CERTIFICATE OF COMPLETION/OPERATION PERMIT

Address of Property 11042 Williams Rd

INSTALLATION, CONSTRUCTION, ALTERATION, AND/OR REPAIR APPROVAL

MECKLENBURG COUNTY HEALTH DEPARTMENT
SITE EVALUATION REPORT
SERIAL NUMBER 028550

PLOT OF SYSTEM Williams Rd

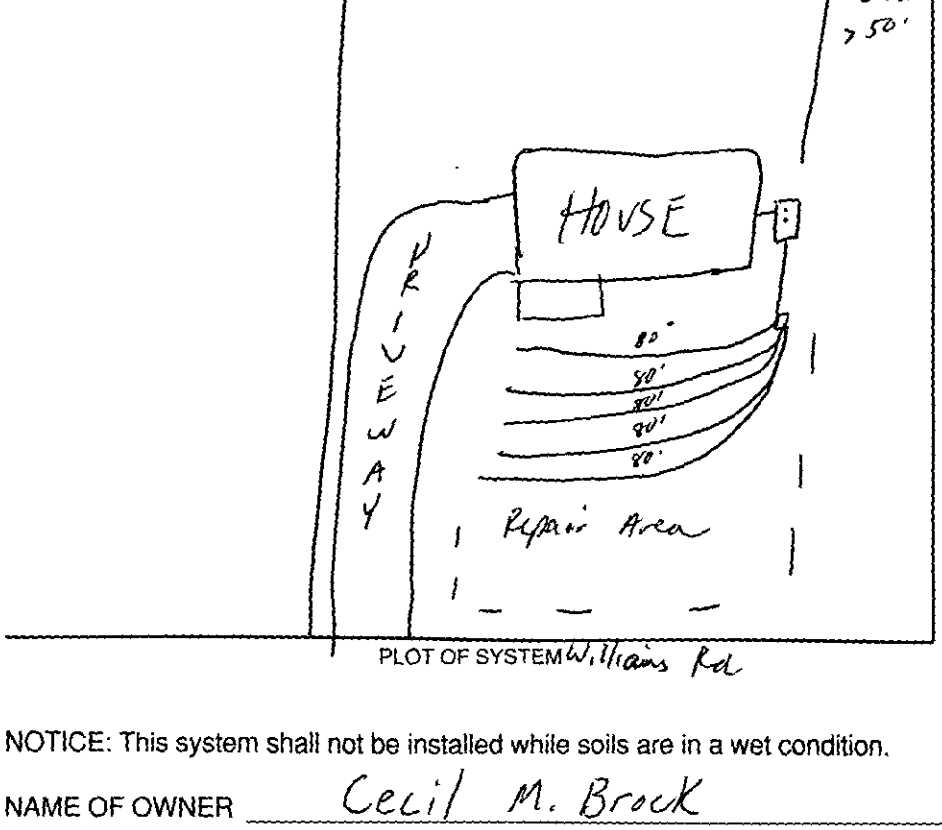
Comments: Keep septic system >100' (50') min for well
5 lines x 80' long x 3' wd x 12" stone Keep lines on contour of land

PROPOSED PLOT PLAN

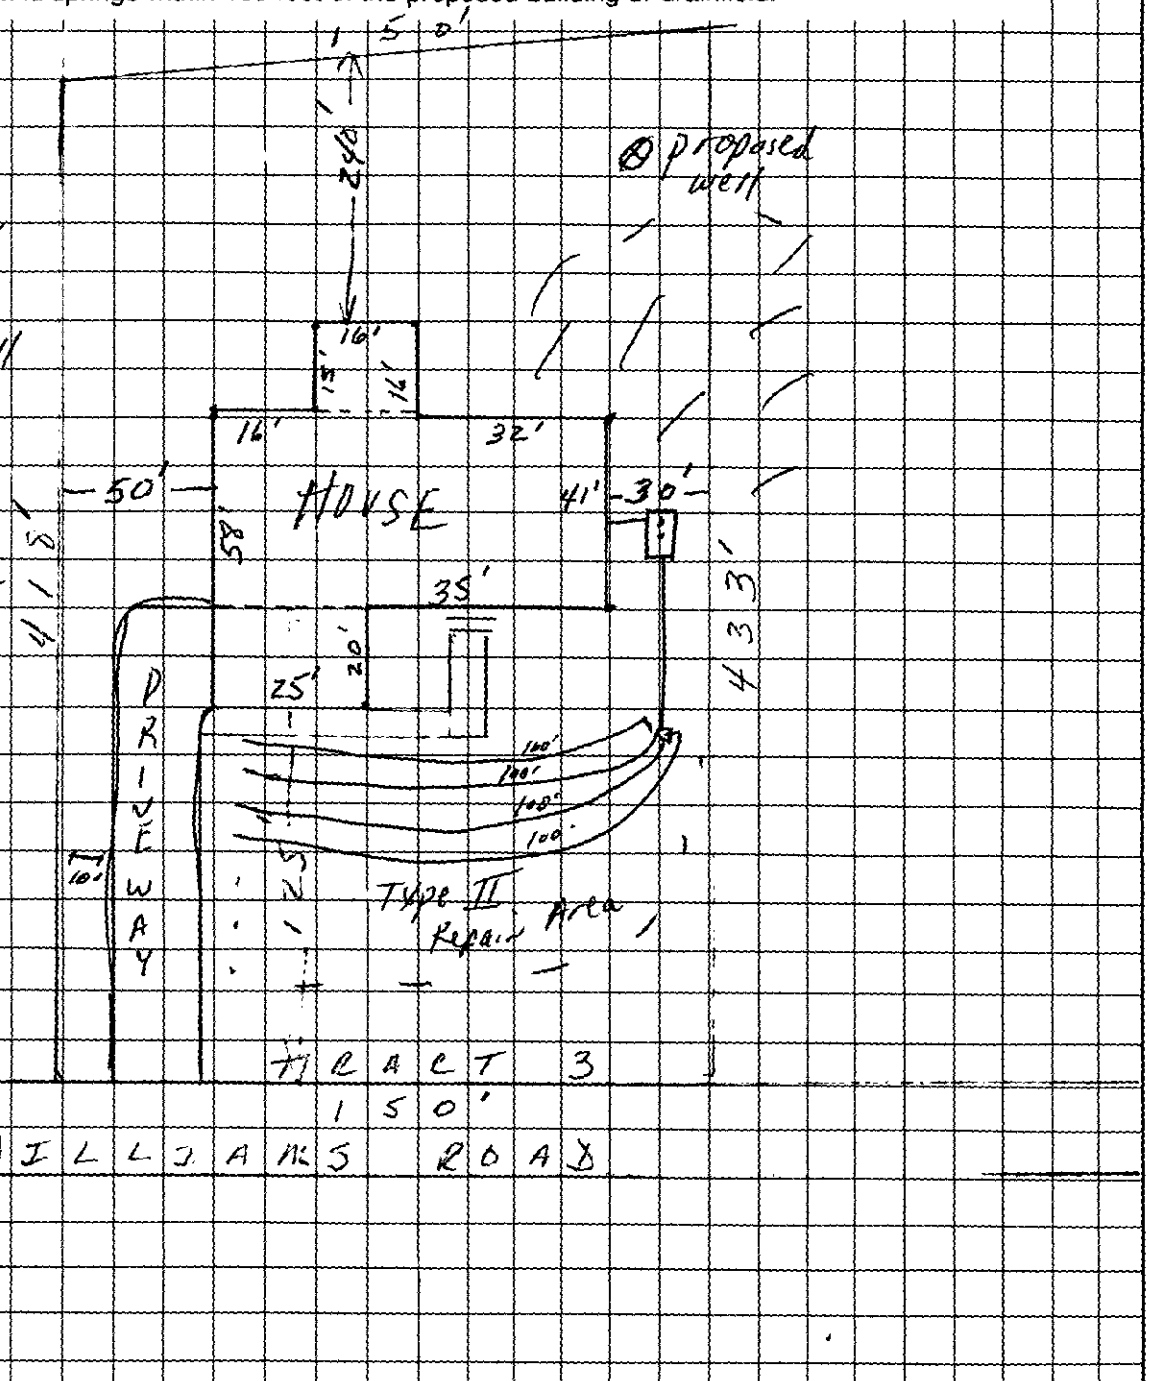
1500 ST
4 lines x 100' long
x 3' wd x 12" stone
400 TLF

Keep proposed well
>50' from any
part of septic
system.
125' from front
property line to
house front.

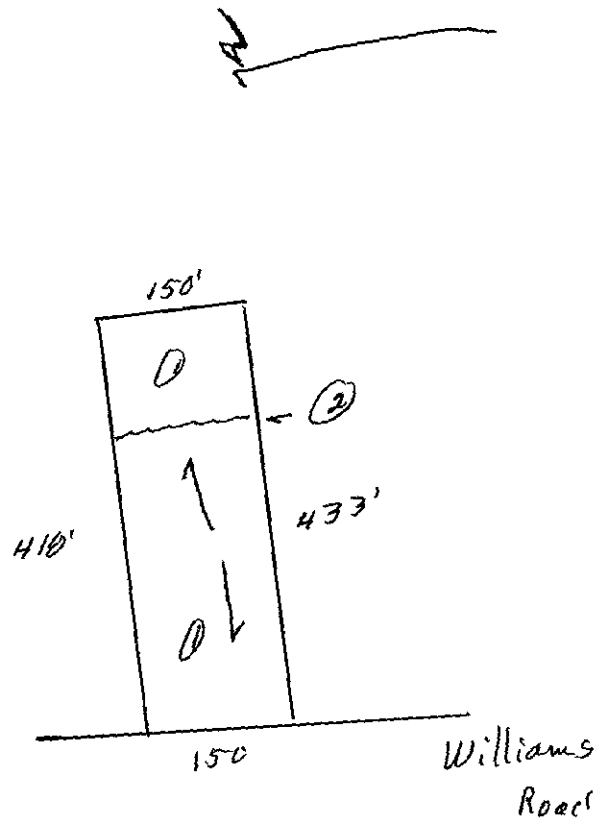
Comments: 100% Repair, 300 gal/ bed/day LTAR
